MEMORANDUM

FILE NO.: VAR2012 0004

PROPOSAL: A Variance request to encroach 25 feet into the 50-foot habitat setback of Bay Creek for the renovation of Auke Bay Elementary School parking lot.

Figure 3: Picture of future staff parking lot marked by dashed black lines next to Auke Bay Elementary School on right. Photograph taken by staff on March 15, 2012

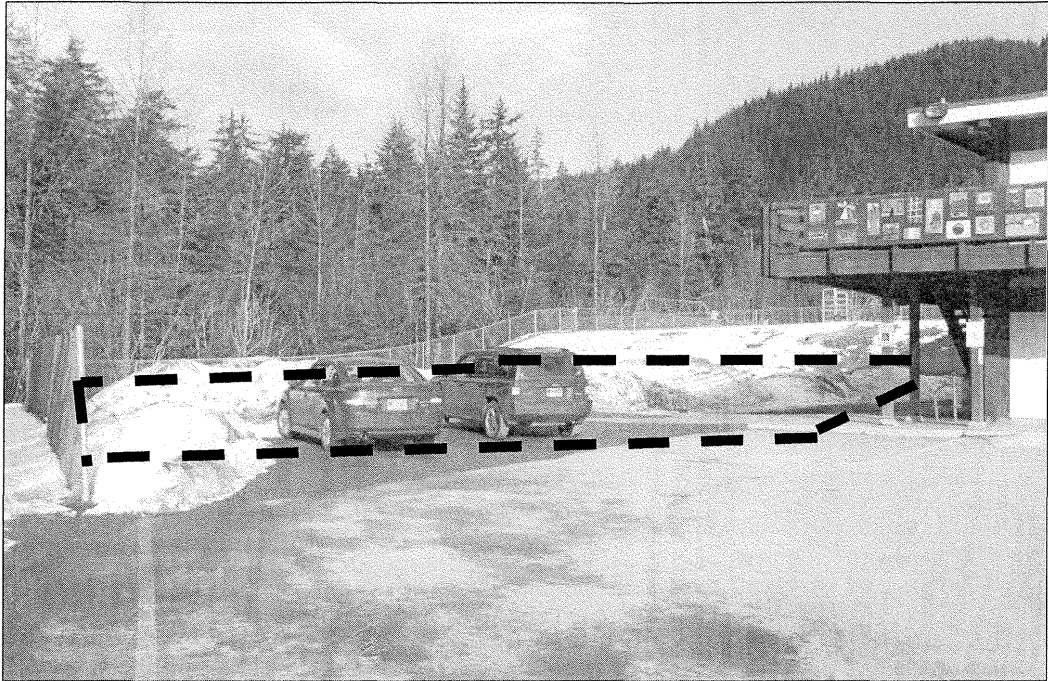
A new staff parking lot has been designed immediately west of the school building, and below the playground. The limits of the parking lot will be within the existing fence line, as seen in Figure 3. This area is currently used as snow storage and parking, and during the summer grass and tall weeds grow here. The new parking lot has been designed to free up other parking spaces for parents and guests. These also will separate users of the parking and will improve overall vehicular circulation. The corner of this parking lot will encroach approximately 15 feet in to the habitat setback, as shown in Attachment C.

SHEET TITLE
SITE PHASING & CONSTRUCTION STAGING

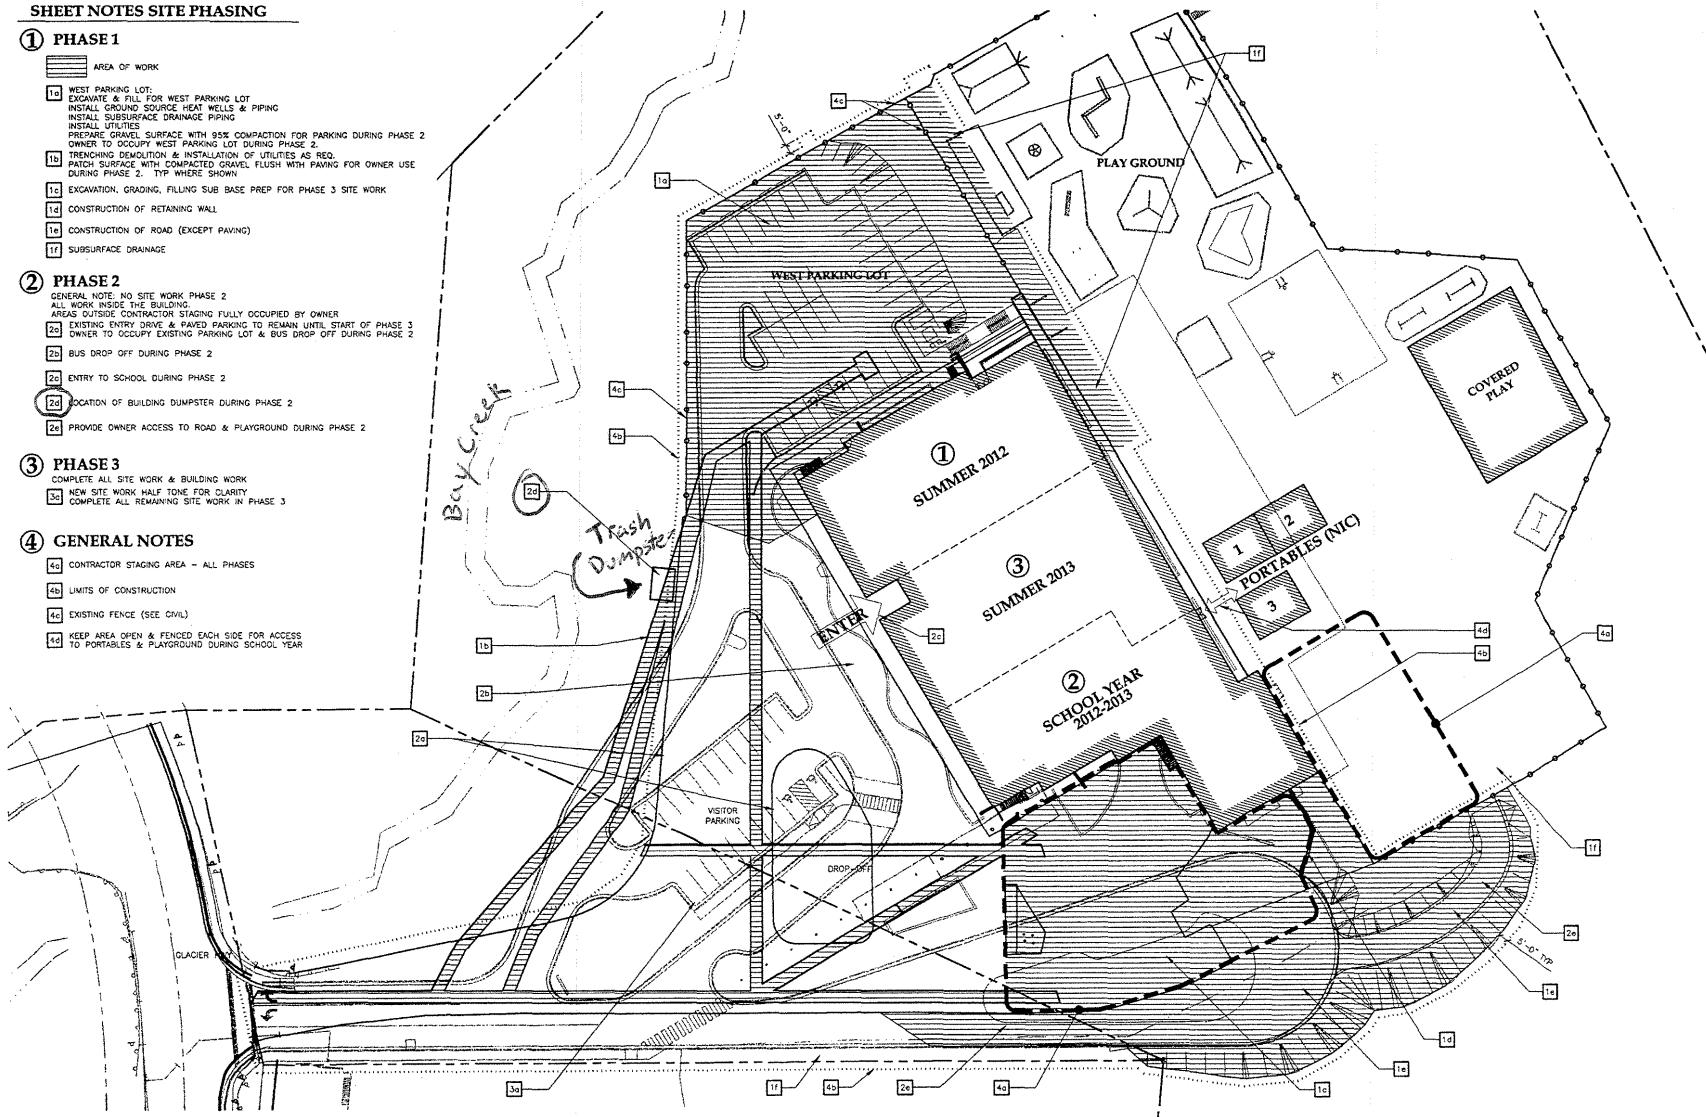
As seen on sheet A101 of Attachment B, a trash dumpster will be located near the 50-foot setback line of Bay Creek during one of the construction phases. Due to the toxic items in trash receptacles, staff is recommending a condition of approval that the dumpster shall be located outside of the habitat setback. Also, shown on the same sheet is an underground utility corridor within the habitat setback. This is a recommended condition of approval of the subject variance and shall not be closer than 25 from Bay Creek.

- 1) Prior to issuance of a Building permit, the applicant shall submit a site plan showing the location of the trash dumpster outside of 50-foot habitat setback.
- 2) Prior to issuance of a Building permit, the applicant shall submit a site plan showing the location of the underground utilities are not closer than 25 feet from Bay Creek.

ATTACHMENT C

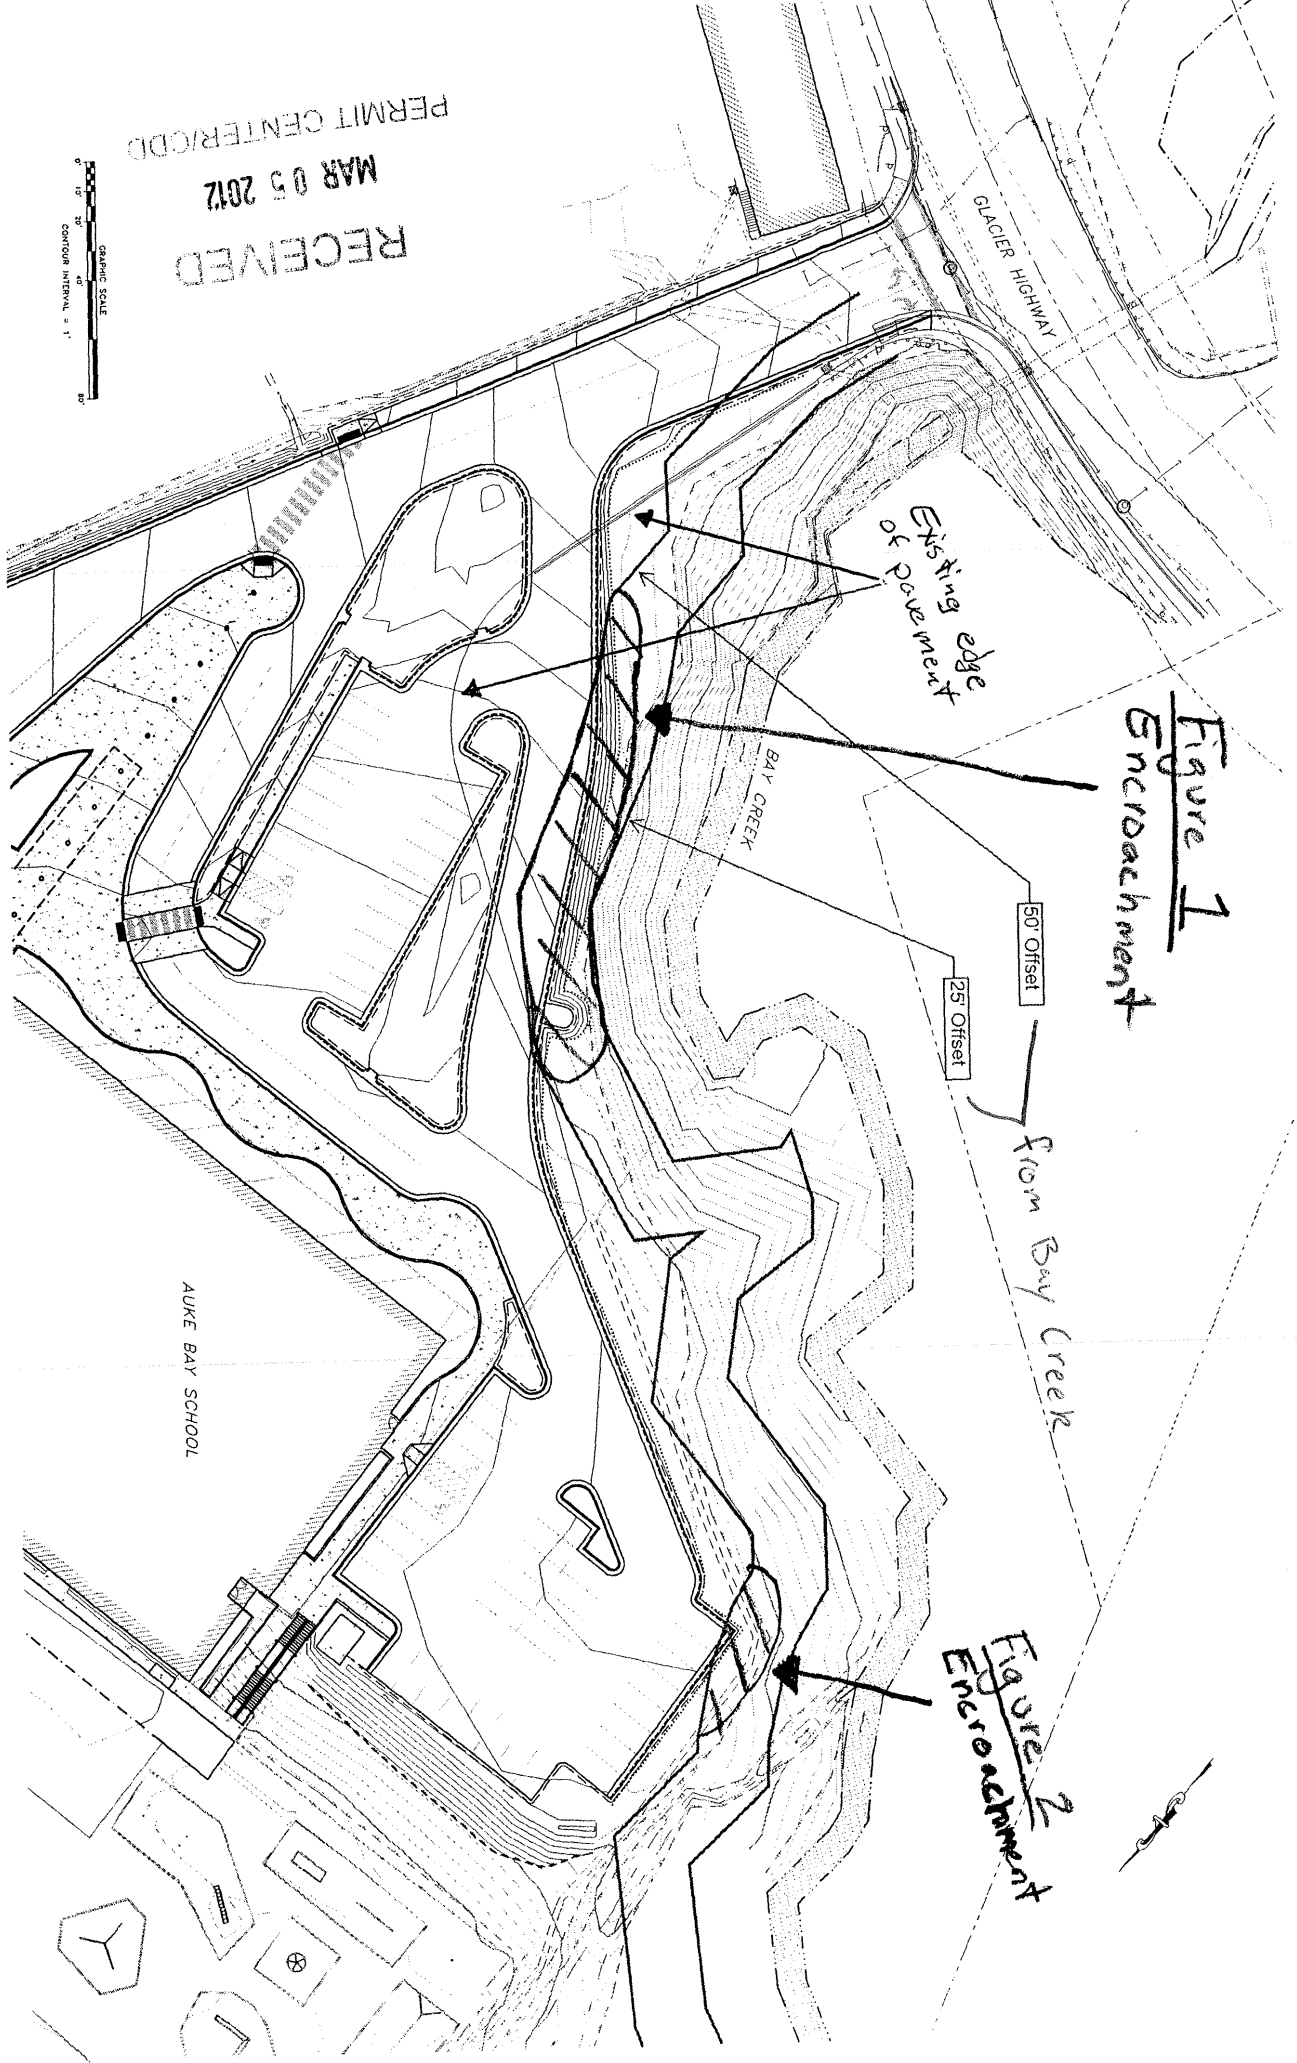
The areas of encroachment are shown in Attachment C. Figure 2 shows a white dotted oval that was said to have been disturbed during the construction of the school during the late 1960s, according to the applicant. Grass is the only vegetation growing in this area, as seen in the figure. From the edge of the trees, the land quickly descends toward Bay Creek. As stated earlier, no trees in the habitat setback will be removed with the project. The grassy area is currently used as snow storage and sometimes for overflow of parking.

The Wetland Review Board strongly opposes development in the 50' setback of Bay Creek and the Board believes that the applicant needs to make a greater effort to avoid impacting this area. Impacts may be reduced by:

- 1) Eliminating the infringement in the southwest corner of the staff parking lot;
- 2) Relocating the fire hydrant and the access pad outside of the 50' setback;
- 3) Shifting the two-way access driveway to the staff parking to the east by reducing the landscaped areas to the west; and
- 4) Using a retaining wall/system to maximize the fill slope (i.e. make it steeper) and minimize the encroachment to the west of the driveway.

- 1) Eliminate the infringement in the southwest corner of the staff parking lot;
- 2) Relocate the fire hydrant and the access pad outside of the 50' setback;
- 3) Shift the two-way access driveway to the staff parking to the east by reducing the landscaped areas to the west; and
- 4) Use a retaining wall system to maximize the fill slope (i.e. make it steeper) and minimize the encroachment to the west of the driveway.
